SUBMISSION TO DRAFT SYDNEY OLYMPIC MASTER PLAN 2030 (2016 REVIEW) AND DRAFT AMENDEMENTS TO SEPP (STATE SIGNIFICANT PRECINCTS) 2005 - 1 FIGTREE DRIVE, SYDNEY OLYMPIC PARK

This letter has been prepared on behalf of Kador Group Holdings Pty Ltd (**Kador Group**), owners of the property at 1 Figtree Drive, Sydney Olympic Park (**subject site**), in relation to the draft Sydney Olympic Master Plan 2030 (**2016 review**) and draft amendments to State Environmental Planning Policy (State Significant Precincts) 2005. The site is described in the Sydney Olympic Park Master Plan 2030 (**Master Plan 2030**) as Site 45.

FIGURE 2 – INTEGRATED BASEMENT CAR PARKING (SOURCE: CITY OF SYDNEY GREEN SQUARE TOWN CENTRE DCP)

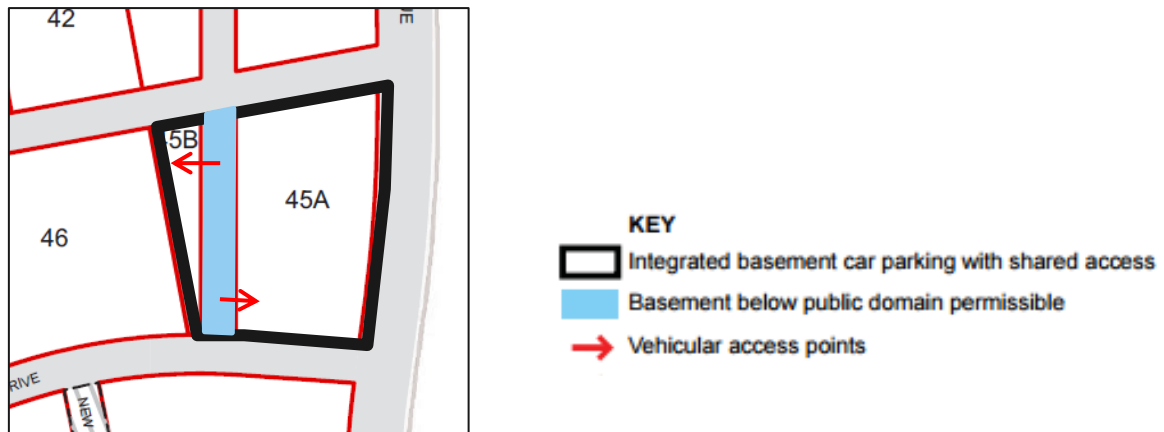
The City of Sydney Green Square Town Centre DCP 2012 permits integrated basements over multiple development sites. Figure 2 highlights the arrangements permitted at Green Square.

We recommend SOPA consider the inclusion of a development control within the Master Plan 2030 that permits integrated basements and basements below public domain including roads. This provision would eliminate the requirement for separate basements for each development site, some
